Technical Service Information

CHRYSLER A518/A618 DRIVESHAFT YOKE DOES NOT FIT OUTPUT SHAFT

Figure 1

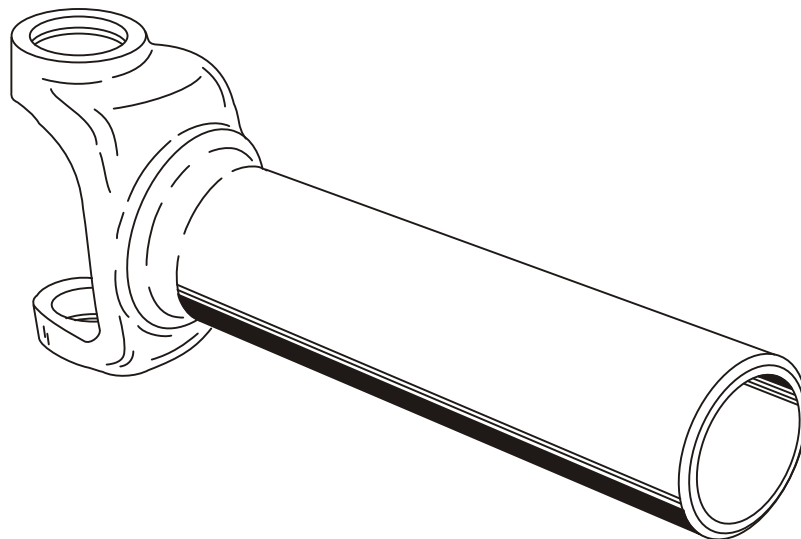
CAUSE: *Late* output shaft in the transmission with *early* driveshaft yoke in vehicle.
Explanation: Chrysler Corporation changed the outside diameter of the output shaft in the spline area, which increased the contact area of the yoke splines for improved durability, and of course the yoke changed at the same time to accommodate the output shaft change, as shown in Figure 1.

CORRECTION: There are two ways to correct this concern. If it is after installation, the easiest way to correct this is to purchase and install the late driveshaft yoke, available under OEM part number 4384437, as it will fit both early and late output shafts.
The only other option is to make yourself a Go-No Go gauge to fit the early output shaft diameter, and remove approximately .050" from the outside diameter of the spline area, if the Go-No Go gauge will not go over your output shaft, and do this before the output shaft is installed into the transmission. This will ensure that the driveshaft yoke will go on the output shaft as you have now made it an early shaft, which either driveshaft yoke will fit.

***"LATE" DRIVESHAFT YOKE
PART NUMBER 4384437 FITS
BOTH EARLY AND LATE SHAFTS***
